HISTORIC AND DESIGN REVIEW COMMISSION

HDRC CASE NO: 2020-041
ADDRESS: 931 HAYS ST
LEGAL DESCRIPTION: NCB 1654 BLK B LOT S 140 FT OF 16
ZONING: R-5, H
CITY COUNCIL DIST.: 2
DISTRICT: Dignowity Hill Historic District
APPLICANT: Nik VILLARREAL/JAS Development
OWNER: LOWRY ALAN J & JOHNSON FAITH E
TYPE OF WORK: Amendment to a previously approved design regarding windows, window fenestration and garage doors
APPLICATION RECEIVED: January 28, 2020
60-DAY REVIEW: March 28, 2020
CASE MANAGER: Edward Hall
REQUEST:

The applicant is requesting a Certificate of Appropriateness for approval to amend a previously approved design for new construction. Within this request, the applicant has proposed the following:

1 LEFT ELEVATION
1/4" = 1'-0"

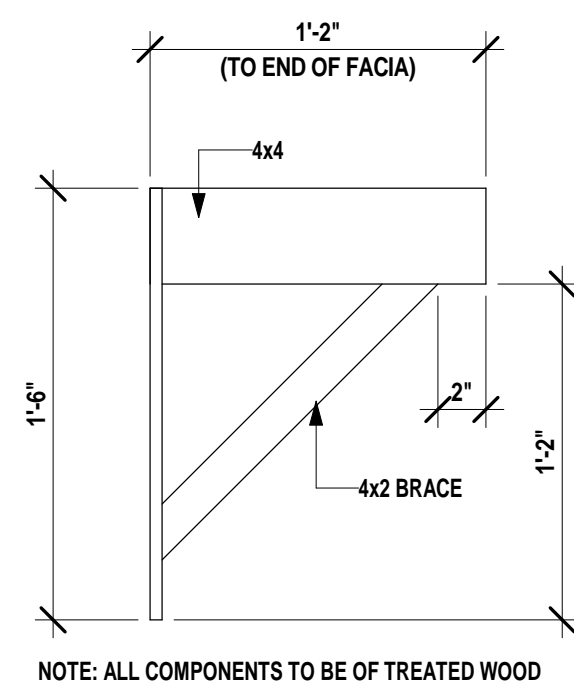
- c. **FENESTRATION** – The applicant has installed a large picture window in place of a transom window on the west façade. While the installation of a larger window is more consistent with those found historically in the district, the profile of the proposed window is inconsistent with the Guidelines and staff's specifications for windows. Staff finds that the window opening should be modified to be more consistent with those found historically within the district.

2. Staff does not recommend approval of item #2, the installation of a large picture window as noted in finding c. Staff finds that the applicant should install a window that is sized appropriately for the district.

3 RECESSED WINDOW DETAIL
1 1/2" = 1'-0"

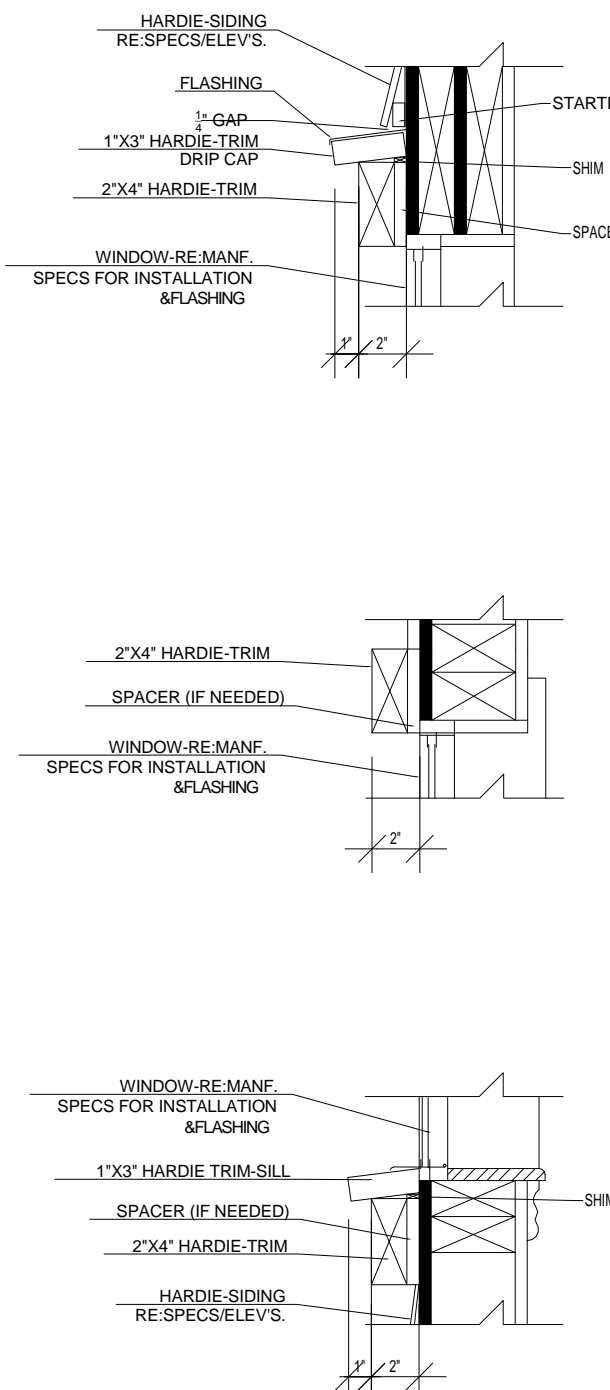
- b. **VINYL WINDOWS** – The applicant has installed vinyl windows in place of the previously approved aluminum clad wood windows. The installed vinyl windows feature a brown colored frames and faux divided lites. Due to a nailing fin, the windows are not recessed at least two (2) inches within the façade. The windows do not comply with staff's windows specifications in regards to material, installation depth, and profile. Staff finds that a window that meets staff's standard specifications should be installed.

1. Staff does not recommend approval of item #1, the installation of vinyl windows. Staff recommends that a window that meets staff's standard specifications be installed, as previously approved. The windows should a double-hung, one-over-one wood windows or aluminum-clad wood windows be used. Meeting rails must be no taller than 1.25" and stiles no wider than 2.25". White manufacturer's color is not allowed, and color selection must be presented to staff. There should be a minimum of two inches in depth between the front face of the window trim and the front face of the top window sash. This must be accomplished by recessing the window sufficiently within the opening or with the installation of additional window trim to add thickness. Window trim must feature traditional dimensions and architecturally appropriate sill detail. Window track components must be painted to match the window trim or concealed by a wood window screen set within the opening.
